## **CALKINS-TROOST-RAINBOW-HAGGERTY STORM LINE REPLACEMENT ADDENDUM #1**

**Project:** Calkins-Troost-Rainbow-Haggerty Storm  
Line Replacement

**Prepared by:** Cole Riley, EIT  
Erik Ranger, PE  
i.e. Engineering, Inc  
809 SE Pine St.  
Roseburg, OR 97470

**Response date:** 03.23.2023

C.4

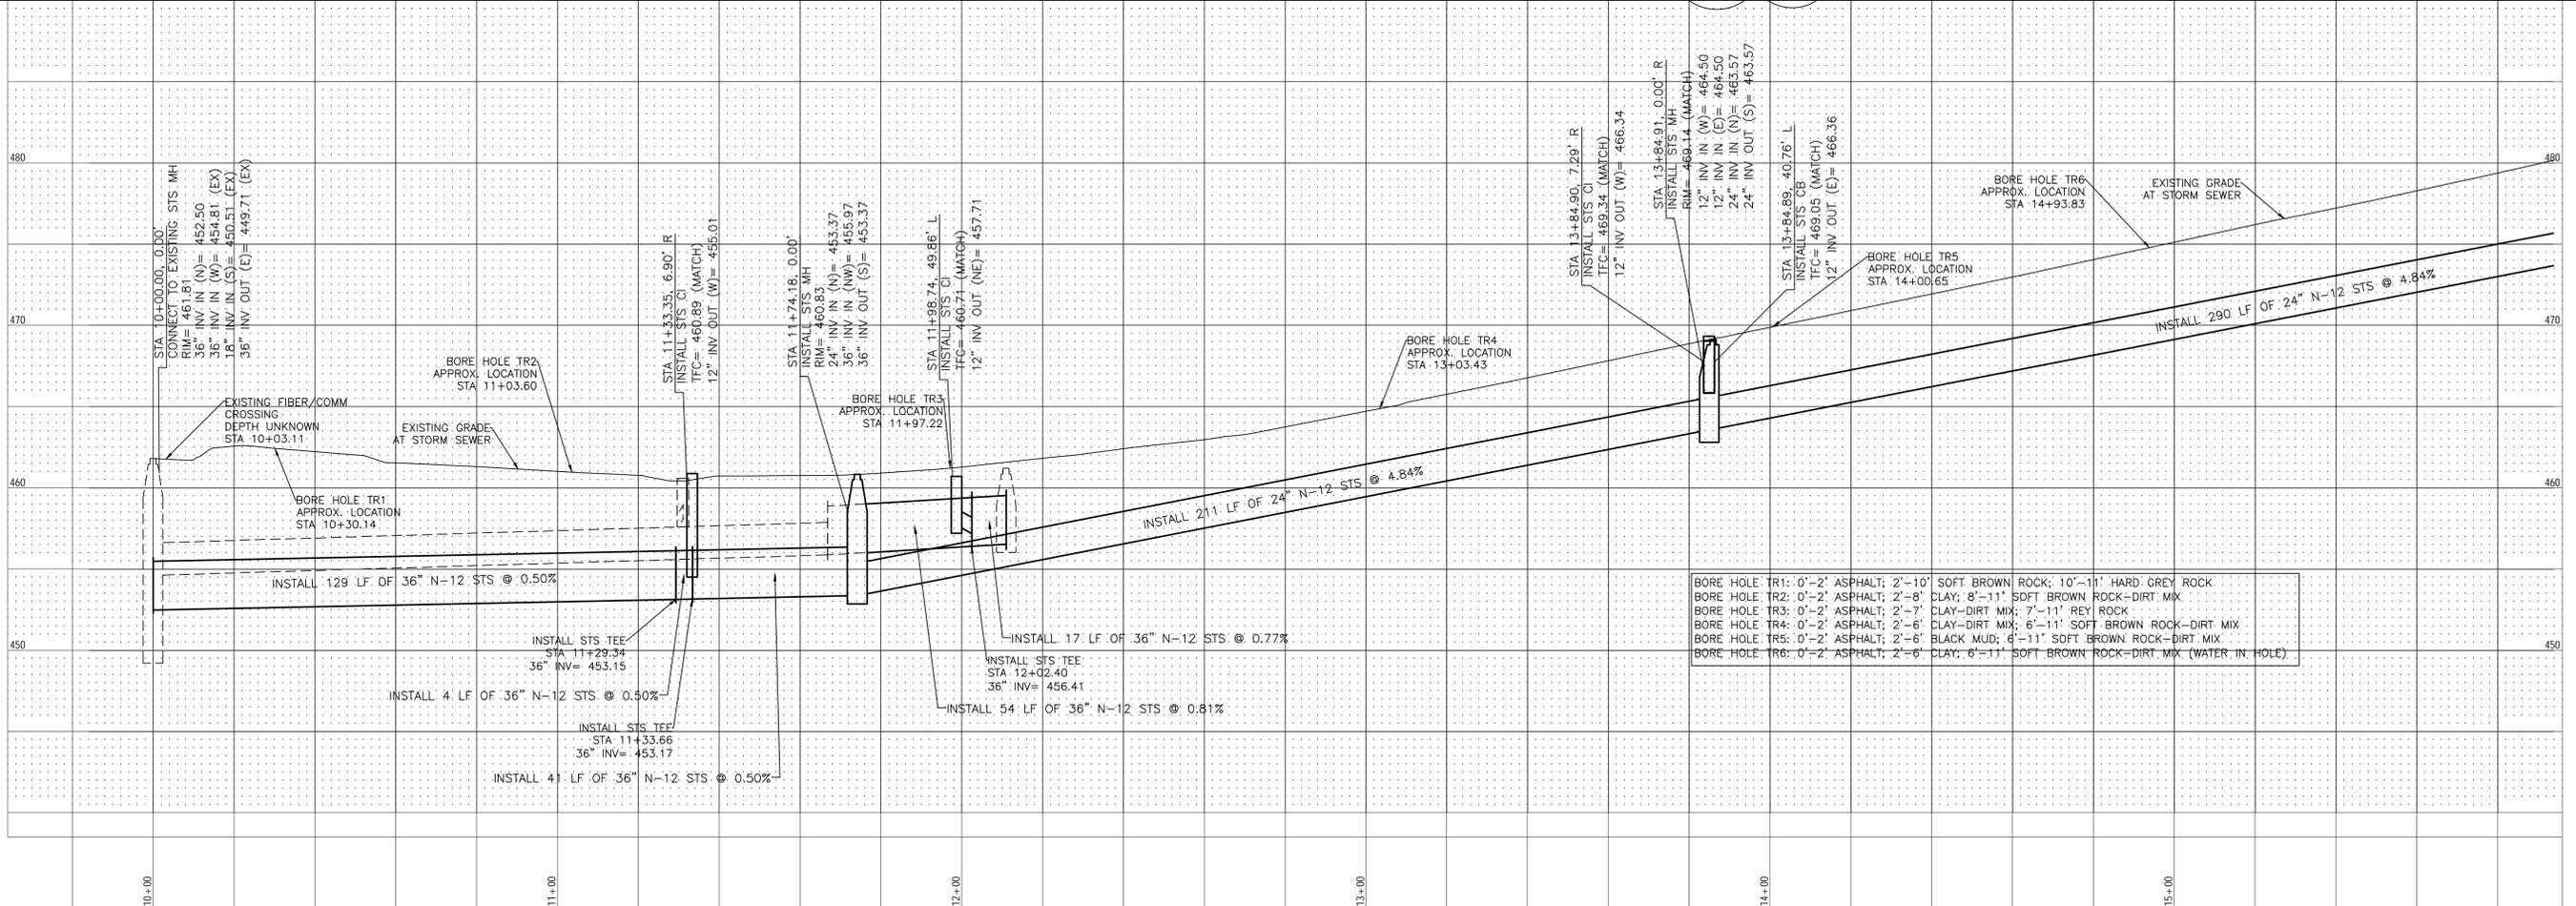
- g. On Sheet C.4, note 24 has been added for removal of existing catch basin. This is paid under BI #5.
- h. On Sheets C.6, C.7, and C.10, the notes that begins "ABANDON EXISTING STS PIPE IN PLACE, ....." has been revised to remove the language "GREATER THAN 12". All pipe sizes to be filled where shown.

# C.6

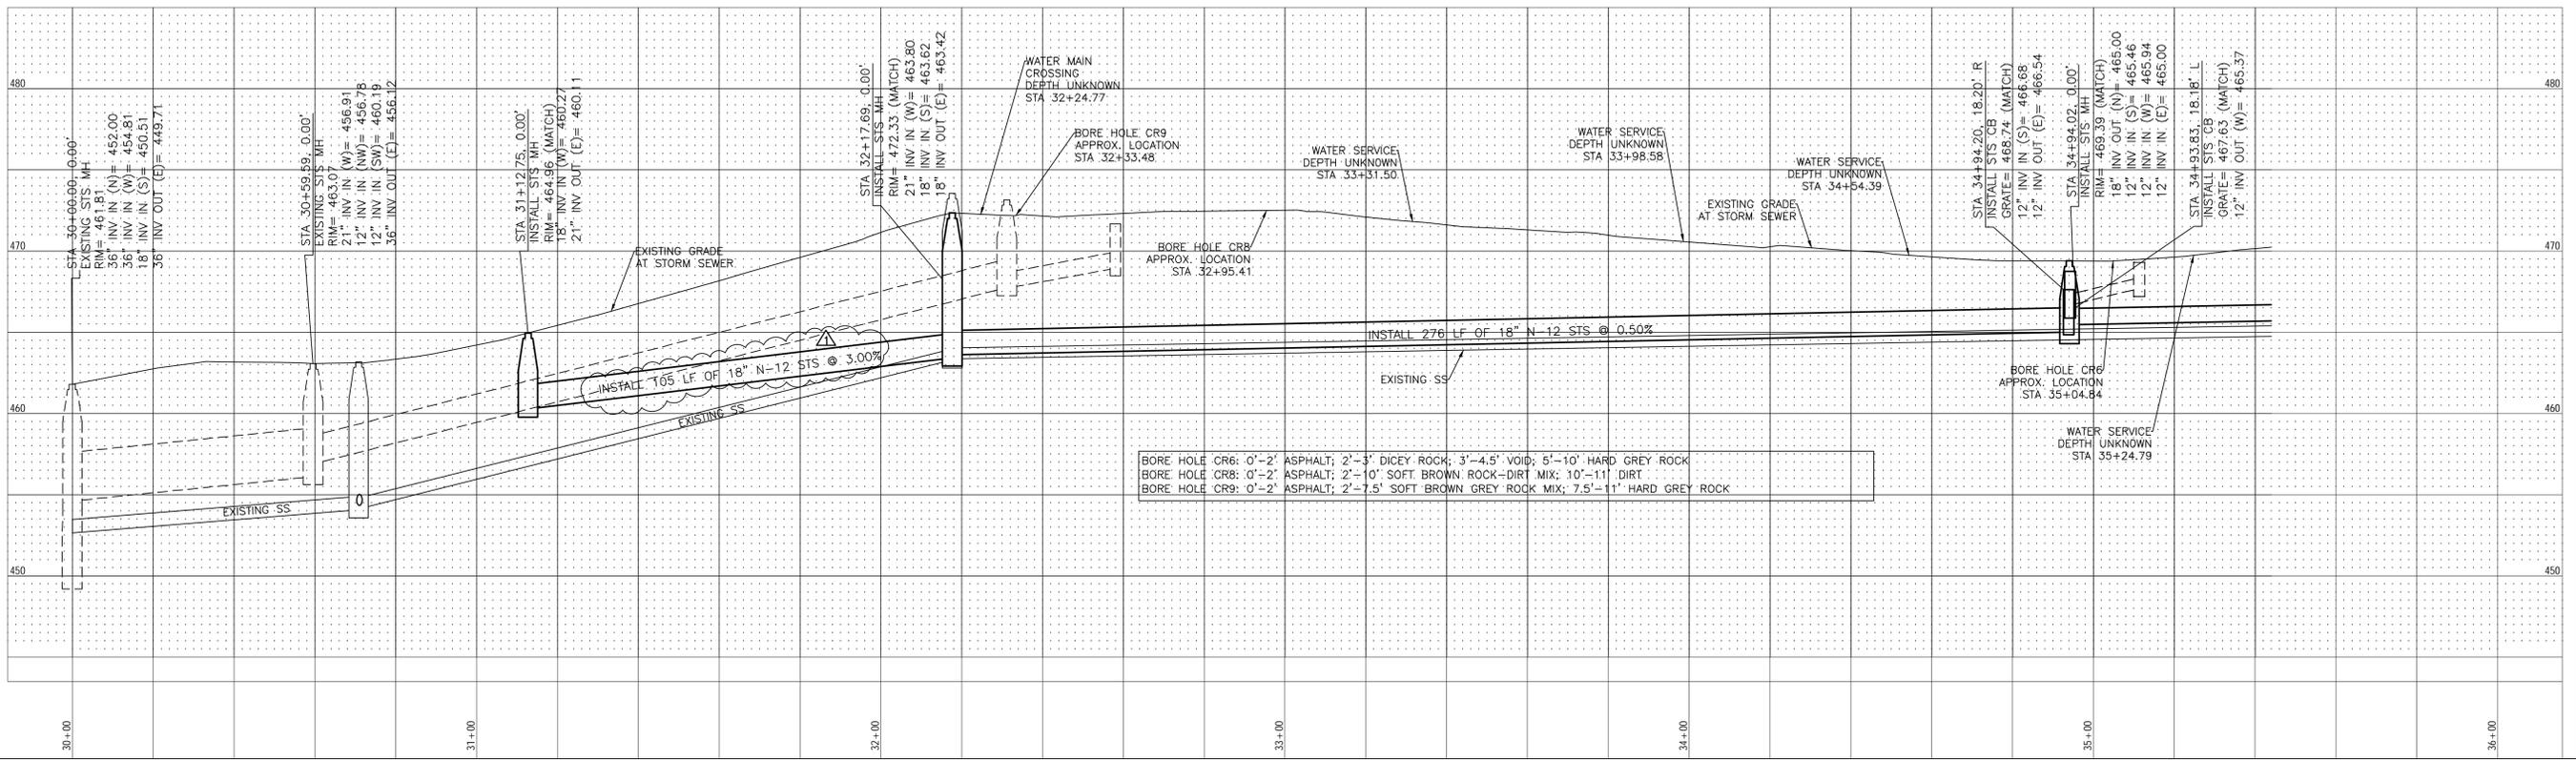
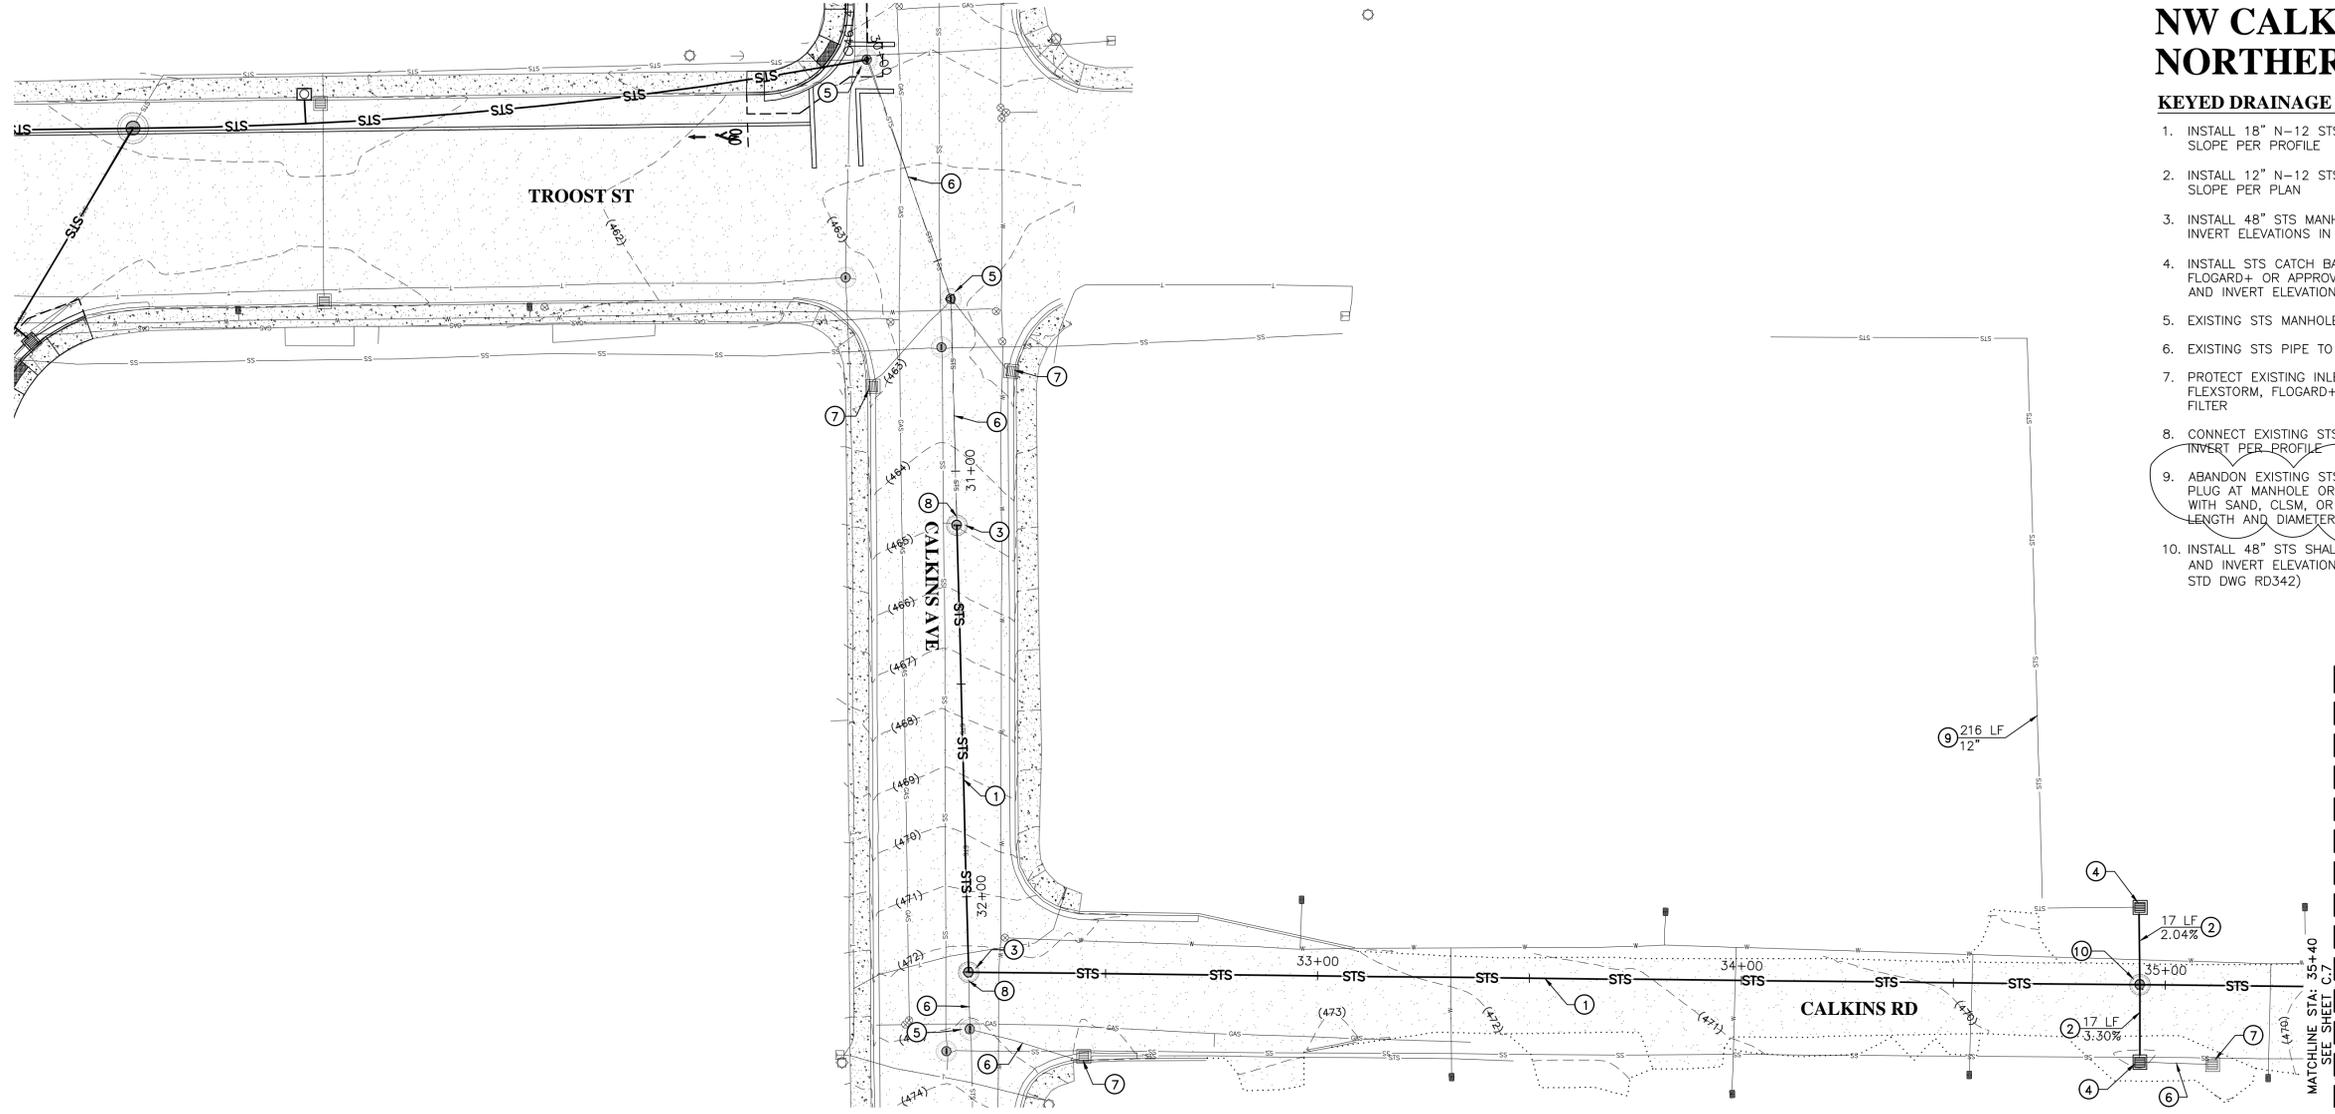
1. Plan sheet C.4, C.6, C.7, C.8, C.9, and C.10 are replaced with revised attached plan sheets. The following is a summary of the revisions.
  - a. On Sheet C.6, the size of the 105 feet of storm sewer pipe, between STA 31+12.75 and 32+17.69, has been changed to an 18" pipe, was previously a 21" pipe.
